PLANT NAME: H.B. Robinson Unit 2

H. B. ROBINSON UNIT NO. 2
LICENSE NO. DPR-23
PLANT ORGANIZATION CHANGES

On December 17, 1974, Carolina Power & Light Company forwarded a proposed revision to the Technical Specifications for its H. B. Robinson Unit No. 2 Plant regarding changes to the Administrative Controls Section 6.0 of the Specifications. This submittal was made in response to your request of October 22, 1974. We later amended this submittal in the area of the Plant and Company Nuclear Safety Committees by a submittal dated February 3, 1975. We understand that these submittals are still under review by your staff and will be issued at a future date.

Figure 6.2-1

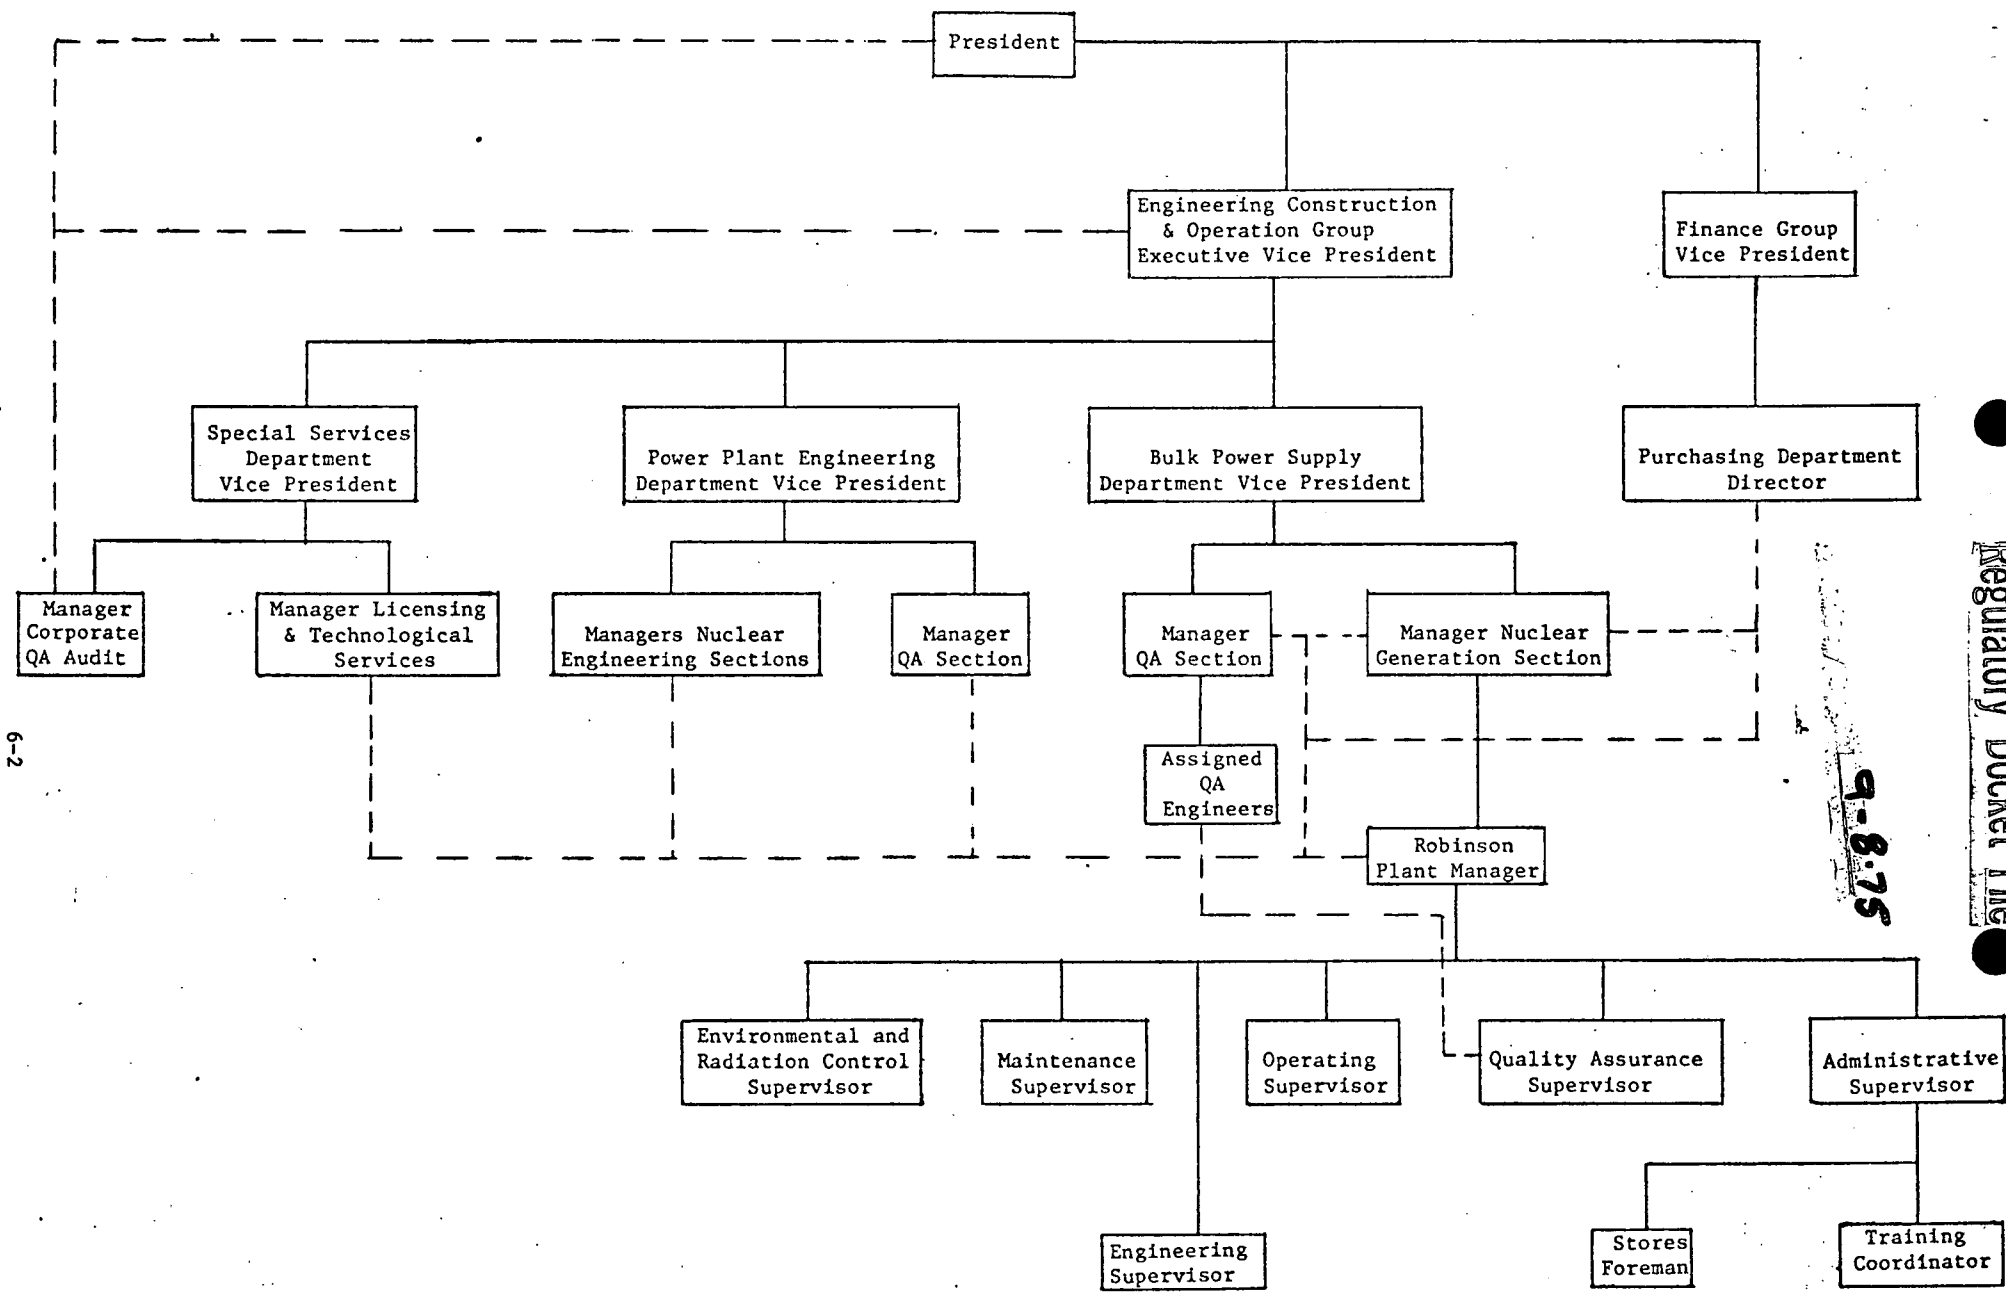
As a result of supervisory changes at the Robinson Plant, we wish to further amend the submittals referenced above to reflect our current plant organization. The changes involved the separation of the duties of the Engineering & Quality Assurance Supervisor into two supervisory functions, an Engineering Supervisor and a Quality Assurance Supervisor. This change was effective July 1, 1975, and was made to strengthen the plant organization in performance of the quality assurance function.

Figure 6.2-2

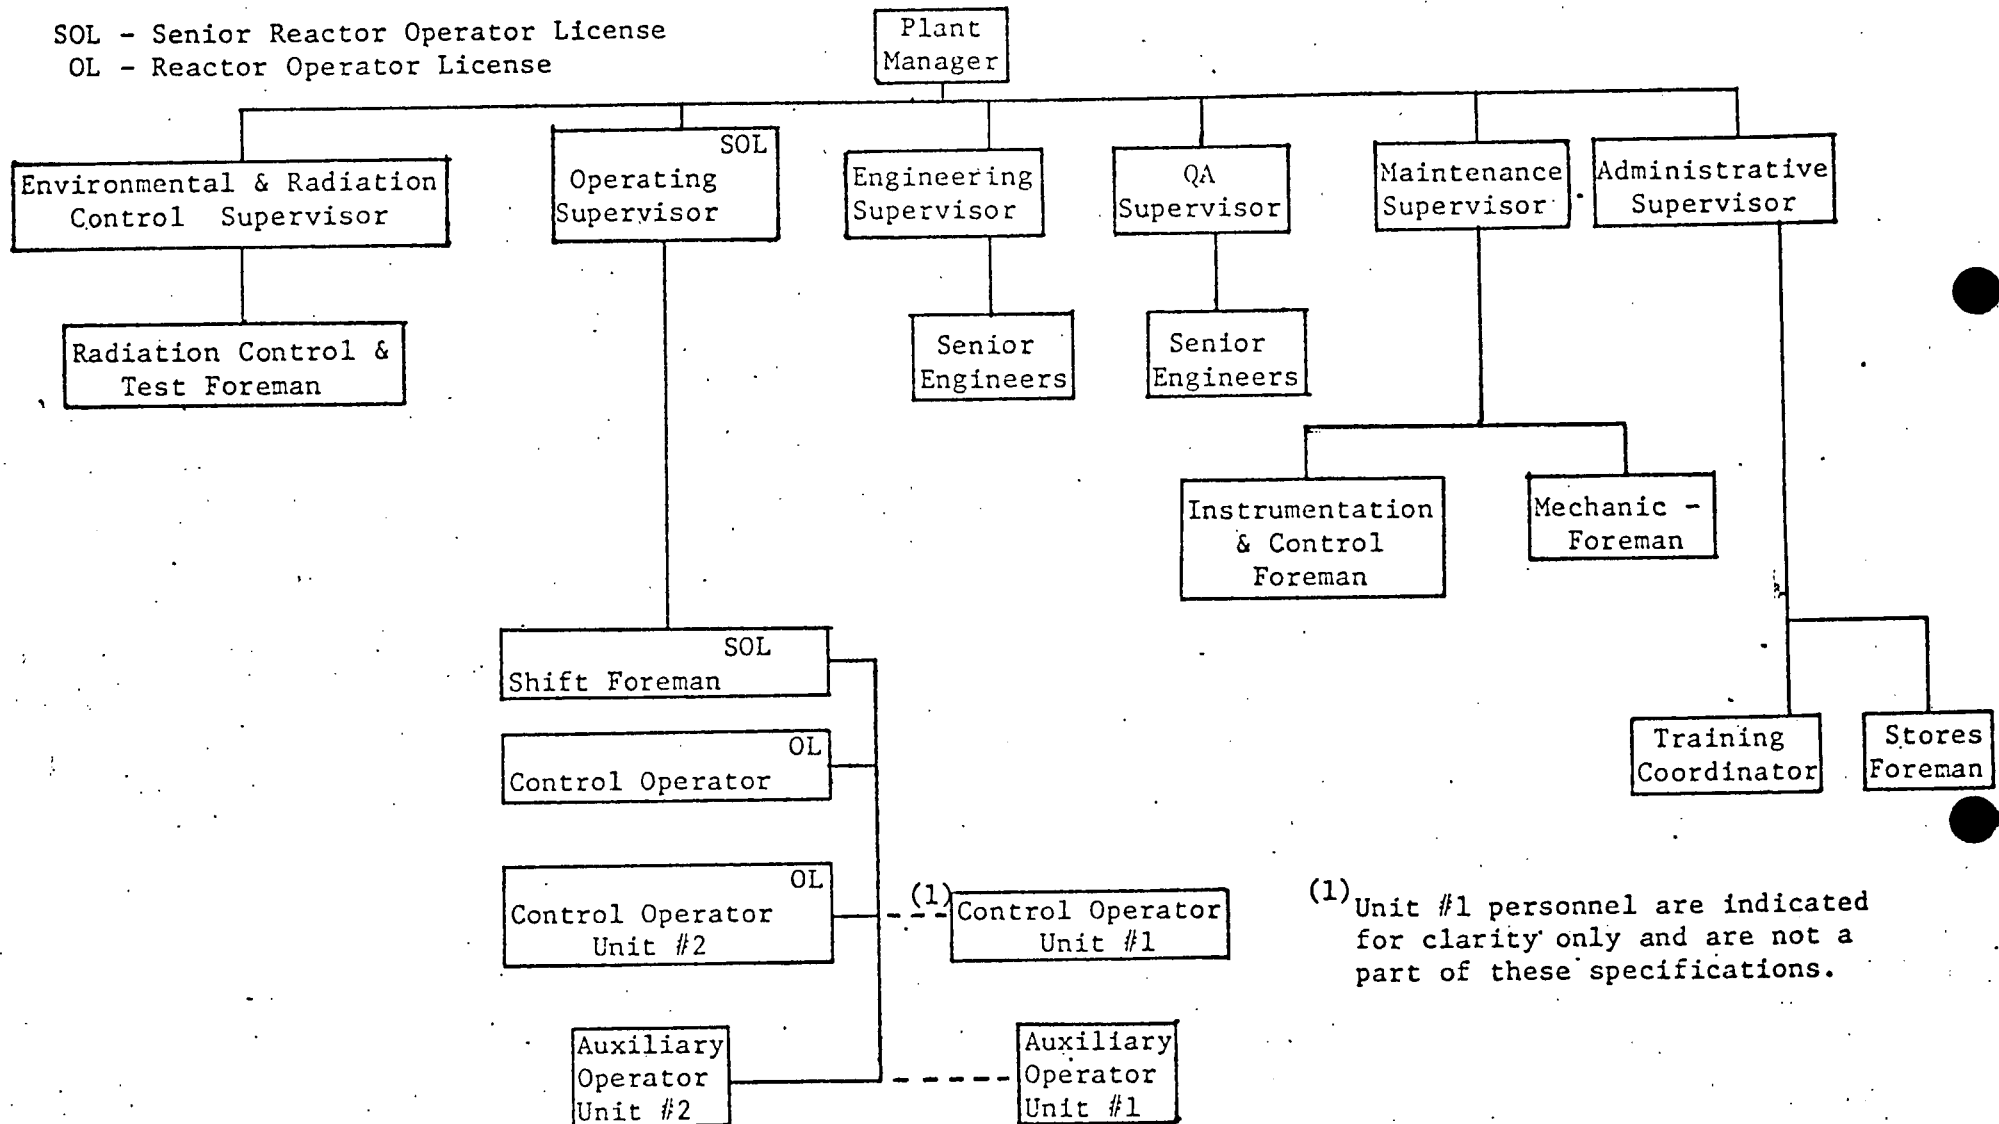
Revised pages to our submittals are attached to this letter showing the changes. In addition, the composition of the Plant Nuclear Safety Committee has been modified to include both the Engineering Supervisor and the Quality Assurance Supervisor as members. This change is reflected on pages 6-4 and 6-5 of the proposed Specifications.

- (a) Chairman: Plant Manager
- (b) Vice Chairman: Operations Supervisor
- (c) Secretary: Administrative Supervisor
- (d) Engineering Supervisor

- (e) Maintenance Supervisor
- (f) Environmental and Radiation Control Supervisor
- (g) Quality Assurance Supervisor
